#### REMARKS

Claims 1-113 are pending. Claims 4, 17-18, 56, 69, 79, 81, 91, 98-99 and 113 are amended for clarity. Claim 114 is newly presented.

Fig. 3

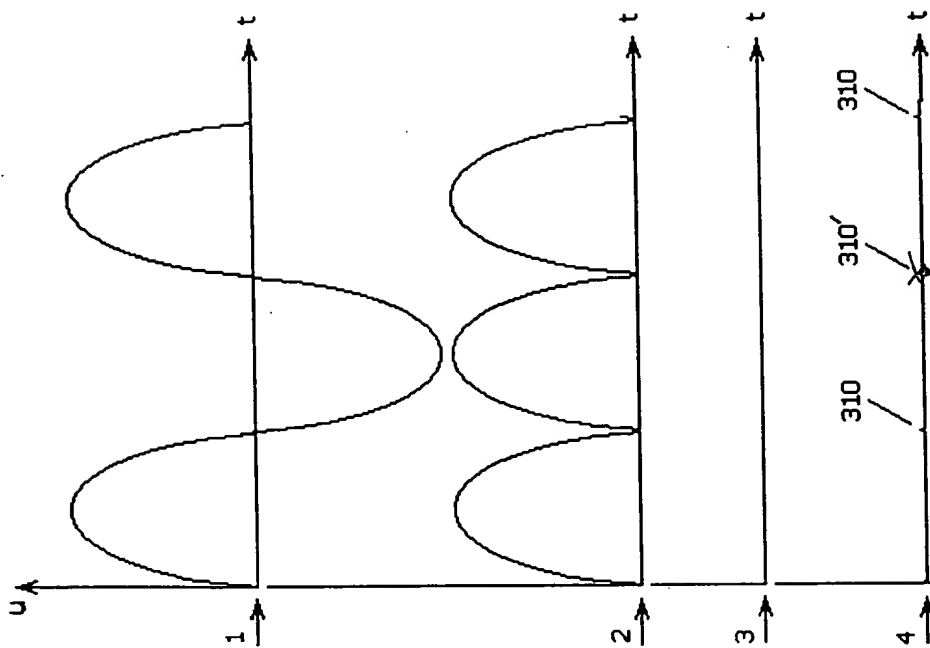
Figure 6b is amended to correct a mislabel, and Figure 3 is amended to show the correct voltage polarity across conducting Liu Switch 300.
